SHOP DRAWINGS — ELECTRICAL / AGL SCOPE

RECTIFICATION OF TWY E BETWEEN E4 & E6 (ZIA)
AGL WORKS AT THREE (3) MILLING LOCATIONS — FIELD CONDITION SCOPE

Document No.	AUH-SK-AGL-TWYE-001 (sheets 1001 / 1002 / 1003) · Revision P08 — FINAL SCOPE OF WORK
Basis of scope	Final scope of work issued 30.07.2026 — supersedes the Rev P06 / P07 field-sheet quantities. Field verification sheets: Document_3 (LOC-01) · Second_milling_area rev _1 (LOC-02 / LOC-03).
Base layer	As-built AGL fitting positions (per assets_20260726120533.xlsx). AS PLOTTED they are ZIA LOCAL PROJECT GRID (m), matching the ADA source drawing to sub-millimetre — NOT UTM 40N. The Rev P05 EPSG:32640 label was incorrect — see sheet 6.
Prepared by	Mohammed — AGL Team Leader, ADB SAFEGATE AGL Team · Issued 28.07.2026 · Rev P08 30.07.2026

SCOPE OF WORK & SEQUENCE — TWY E (E4–E6) · REV P08 (FINAL SCOPE)

LOCATION 3 — 1003 · REV P08 (FINAL SCOPE)

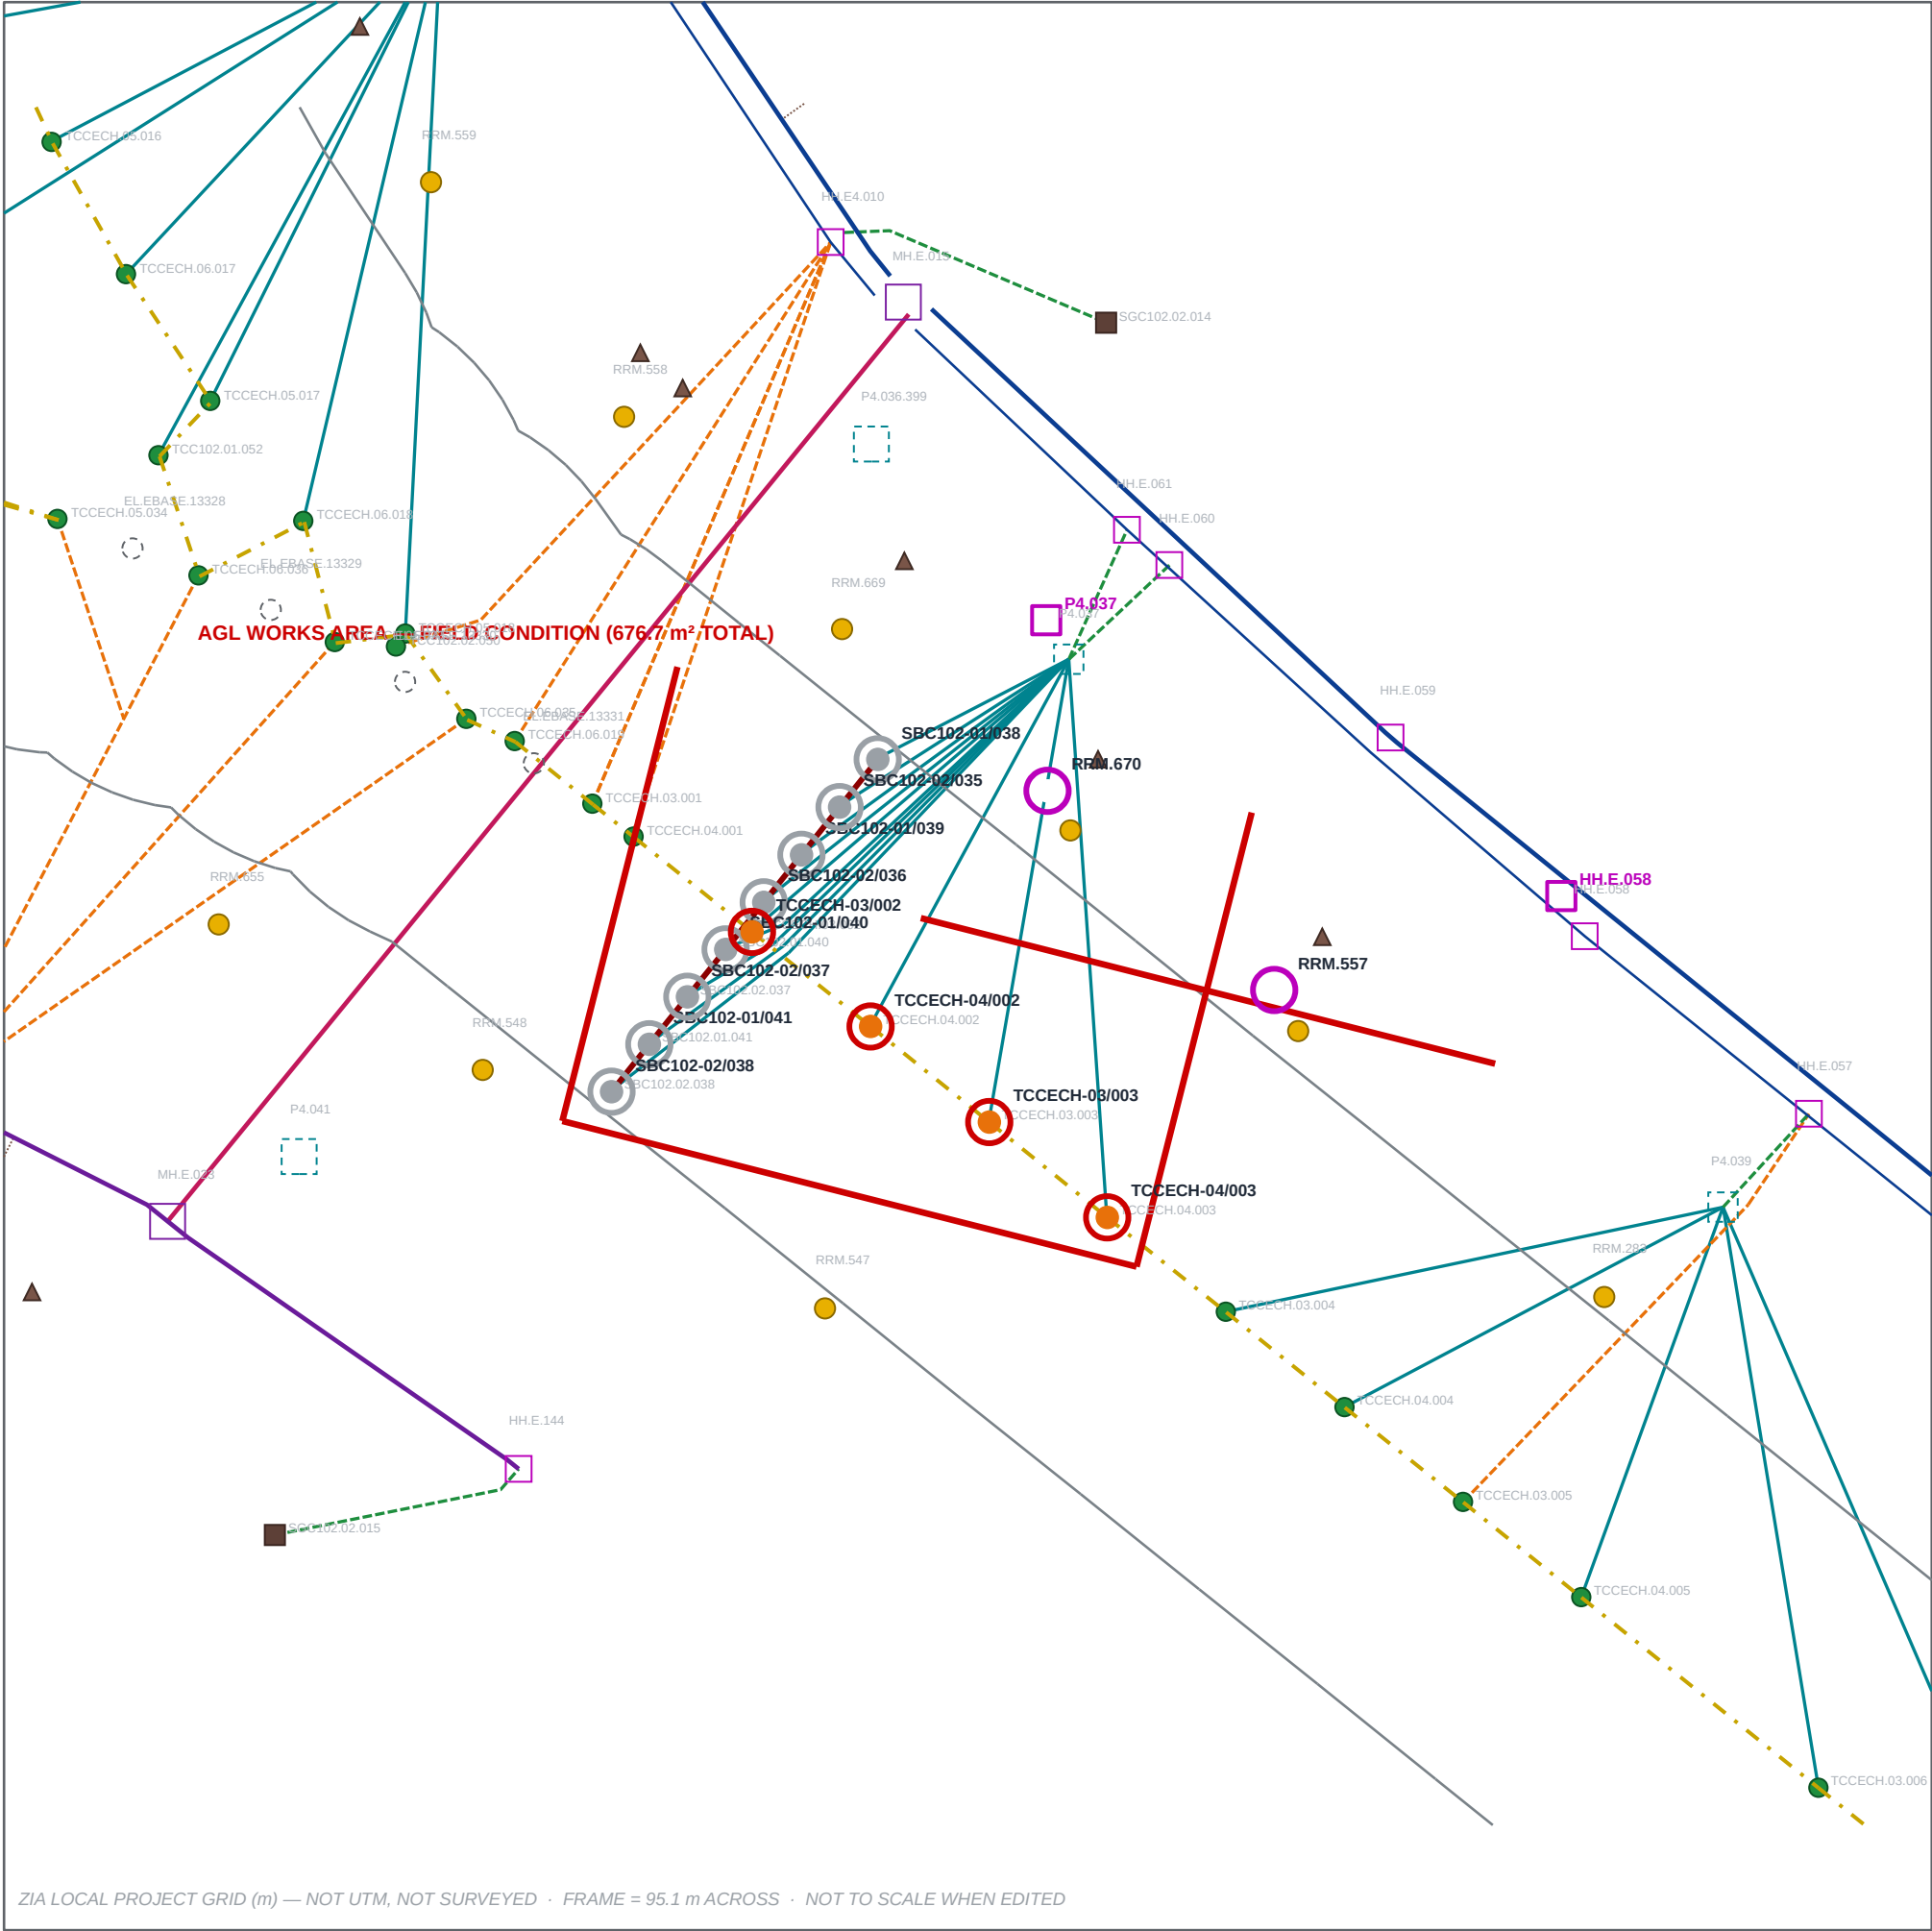
FINAL SCOPE (REV P08) — 4 No. TCC ONLY, SAW CUT
NEW 12" SIDE-ENTRY SHALLOW BASE + NEW CABLE: 4 No.
• TCCECH-03/002, 04/002, 03/003, 04/003
ROUTE: SAW CUT — these 4 No. were carried as VIA DUCT on Rev P06/P07.
Saw cut detail per sheet SAW CUT & SIDE-ENTRY SHALLOW BASE DETAIL — detail drawing to be issued.
REMOVED FROM SCOPE AT REV P08 — no works, 8 No. SBC:

• SBC102-01/038, 01/039, 02/035, 02/036 (EP7 STOP BAR — was sawcut, base protect)
• SBC102-01/040, 01/041, 02/037, 02/038 (was new cable only, via duct)
RRM.557 (0.07 m — treat as within works) & RRM.670: REMOVE / PROTECT / RE-FIX
ISOLATE CIRCUITS: TCCECH.03/04 — SBC102.01/02 carries no AGL works here at P08;
confirm isolation against the saw cut alignment before works.
REV P08 SUPERSEDES the Rev P06/P07 quantities. SUPERSEDED = no works; NOT a field verification that the asset is unaffected.
RED AGL WORKS AREA = Rev P05 field-condition milling extent, UNCHANGED at P08 — the civil milling limit, not a hull of the affected assets.
